Date: August 30, 2013
To: Sam Rodriguez, Mill Creek Residential Trust
From: Mark Walhood, City Planner
503-823-7806, mark.walhood@portlandoregon.gov
Re: 13-167837 DA – MAC Block 7 Apartments & Garage
Design Advice Request Summary Memo: August 15, 2013 DAR

This memo summarizes **Design Commission** design direction provided at the August 15, 2013 DAR.

MADISON ST ELEVATION

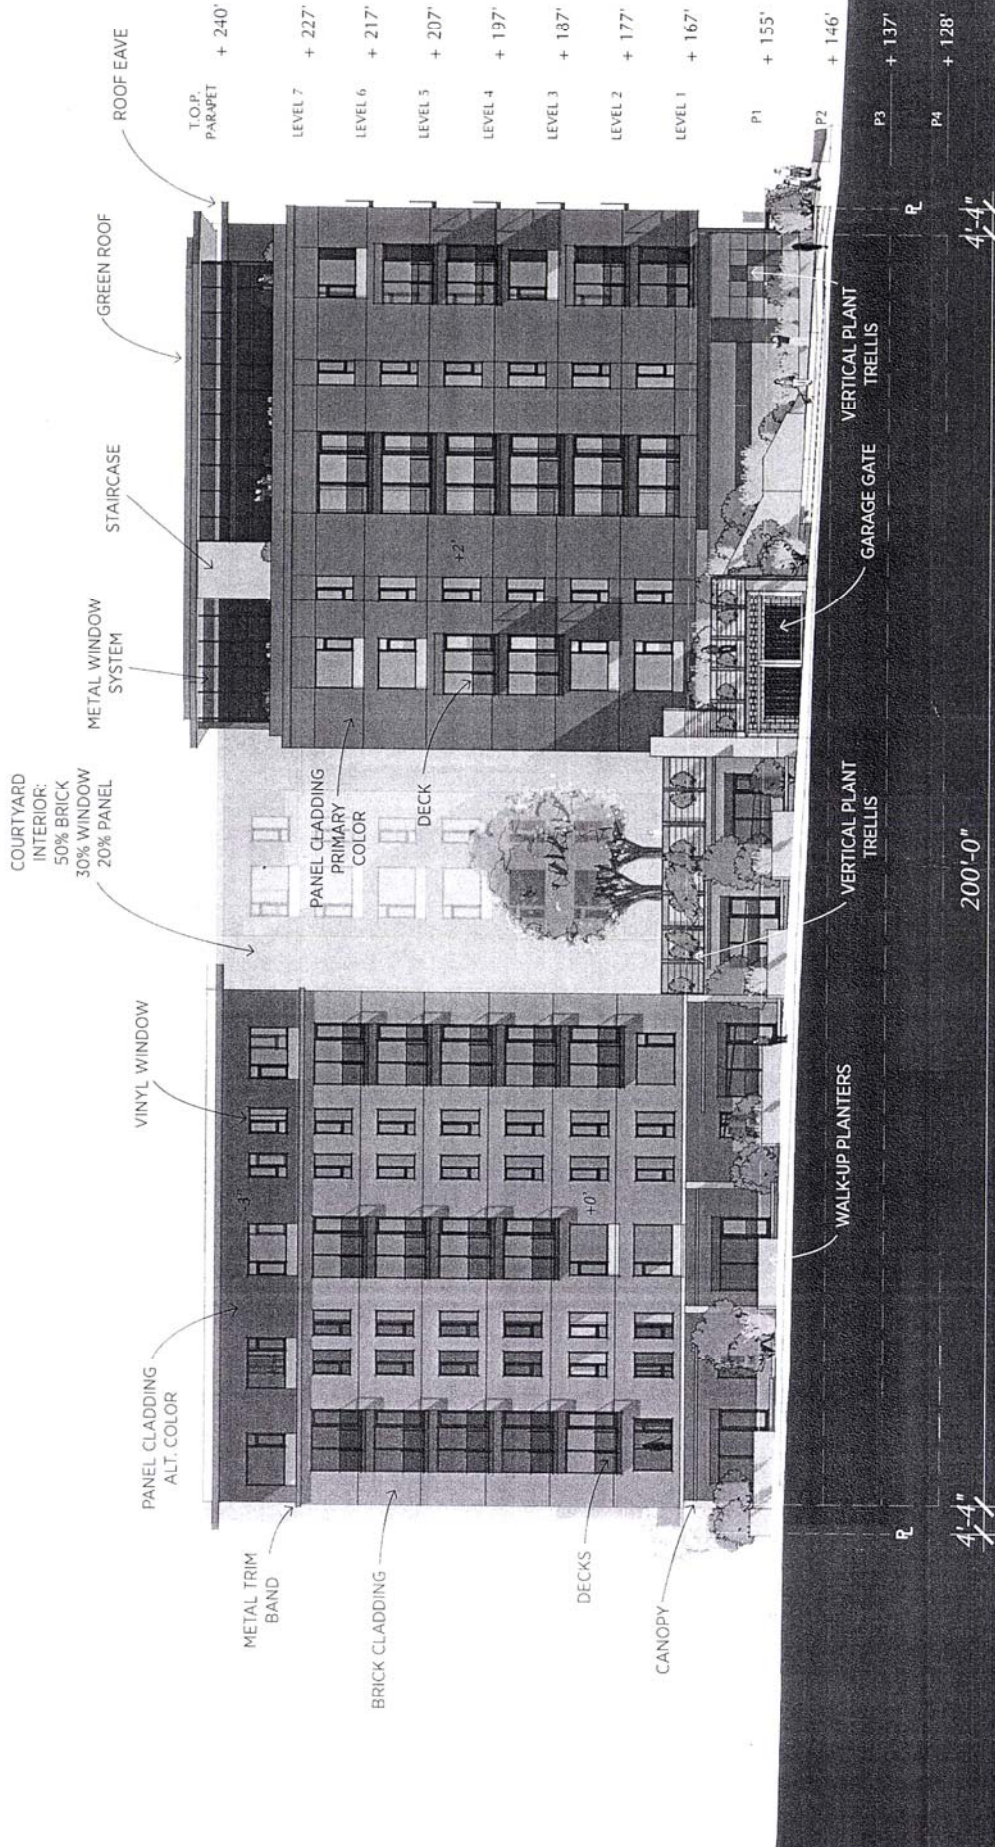
- The garage entry along the south side of the project appears to be the most problematic of the three, considering the immediate adjacency to the older homes across SW Madison Street. Traffic and glare impacts resulting from this driveway can hopefully be avoided by moving the driveway onto either SW 19th or Main.

- It may be helpful to reduce the total amount of parking spaces, in addition to re-locating the south/Madison garage entry.
- When returning for another DAR or during the Design Review, please present further information on how the parking circulation is expected to work, why the various driveways are proposed in each location, access options considered during design development, etc. We are suggesting that the three entries be reduced at least to two, but additional background will be helpful to this discussion.
